PYLANT SUBDIVISION

APPLICATION NUMBER 11 DATE March 19, 2009

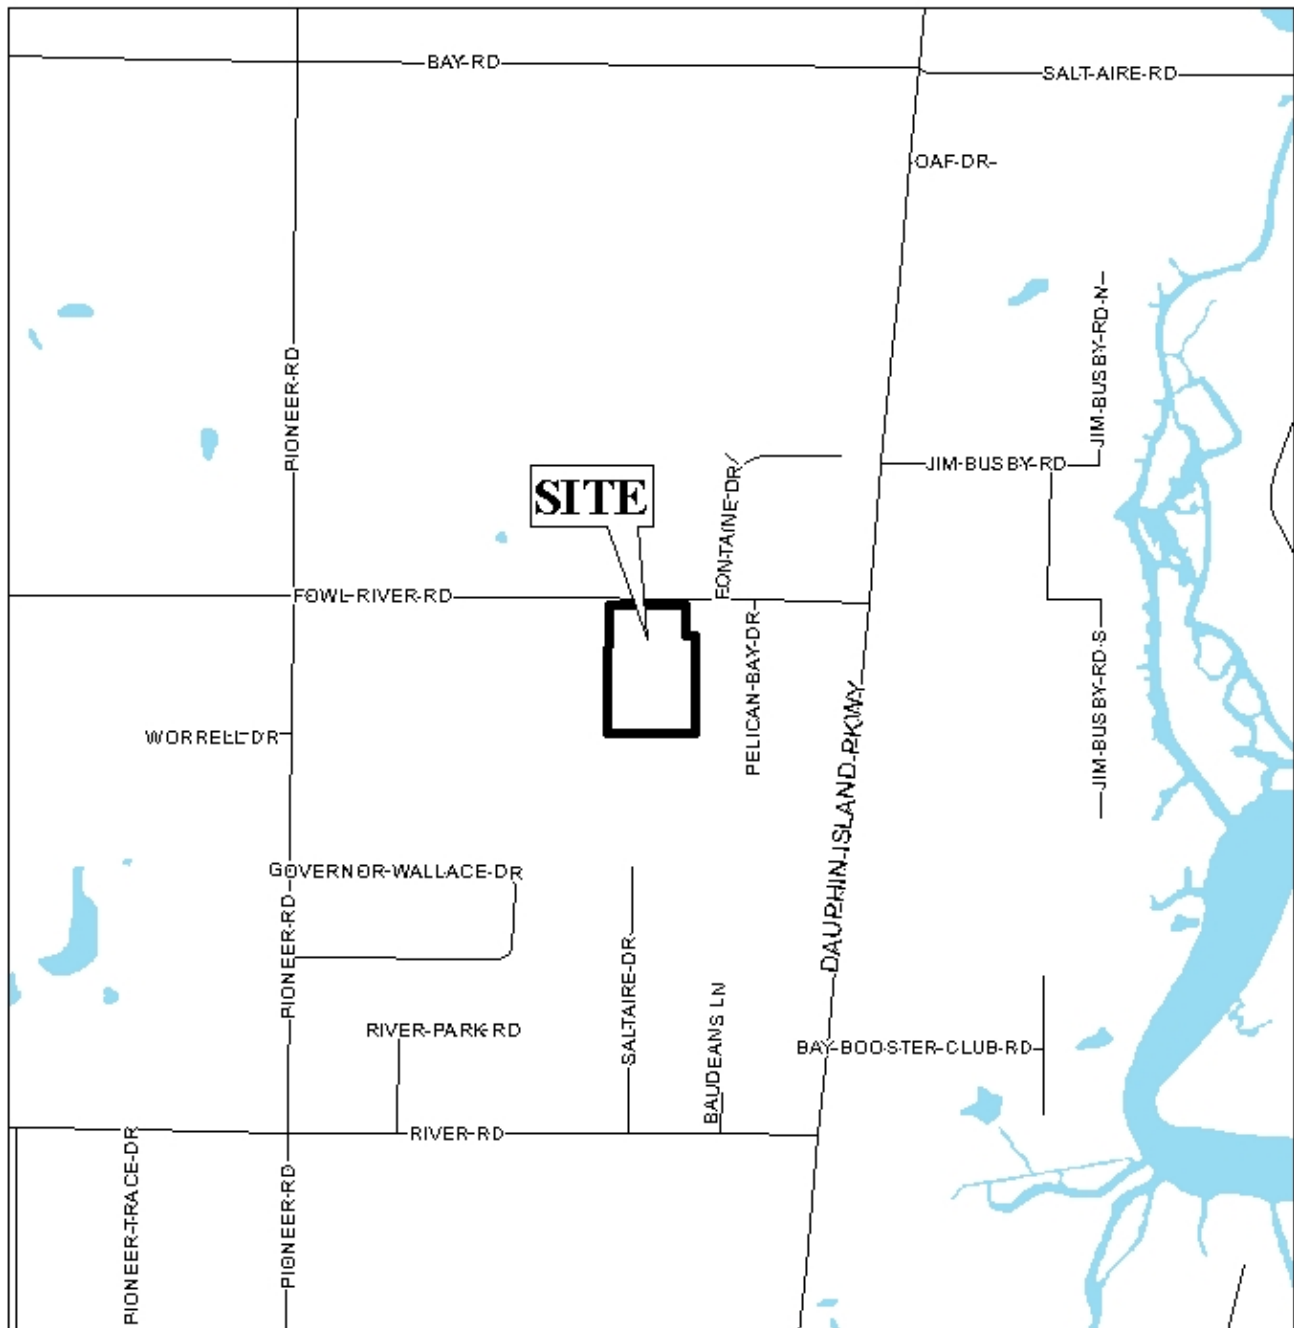
The plat illustrates the proposed 3 lot, 6.02 ± acre subdivision which is located at 3371 Fowl River Road (Southside of Fowl River Road, 322'± West of Pelican Bay Drive). The applicant states that the subdivision is served by public water and individual septic tanks.

The proposed lots meets the minimum size requirements as regulated by Section V.D.2 of the Subdivision Regulations. The proposed lot size is indicated (in square feet) on the plat and should be retained on the final plat, if approved.

The proposed Lot 1 and Lot 2 meet the requirements of Section V.D.3 of the Subdivision Regulations regarding the maximum depth of lots, albeit barely for the proposed Lot 1. The proposed Lot 3, however does not meet this requirement. The proposed Lot 3 is 75 feet wide at the setback line, and it is 343.29 feet deep. The maximum depth allowed for a 75-foot wide lot is 262.5 feet. It should be noted that to the northwest of the site, there are several existing lots which would not meet the width to depth requirements of the Subdivision Regulations, therefore, a waiver of Section V.D.3 may be appropriate.

The 25-foot minimum building setback line is shown on the plat, and should be retained on the final plat, if approved.

The site fronts Fowl River Road, a minor street, not provided with curb and gutter. The plat depicts an adequate 60-foot right-of-way for Fowl River Road, therefore, no dedication should be required.

The site currently has one curb cut to Fowl River Road. A note should be placed on the final plat limiting each lot to one curb cut to Fowl River Road, with the size, design, and location of all curb cuts to be approved by Mobile County Engineering.

Based on the preceding, and with a waiver of Section V.D.3 of the Subdivision Regulations, this application is recommended for approval, subject to the following conditions:

- 1) Retention of the 25 foot minimum building line on the final plat;
- 2) Retention of the lot size labeling (in square feet) on the final plat;
- 3) Placement of a note on the final plat limiting each lot to one curb cut to Fowl River Road, with the size, design, and location of all curb cuts to be approved by Mobile County Engineering;
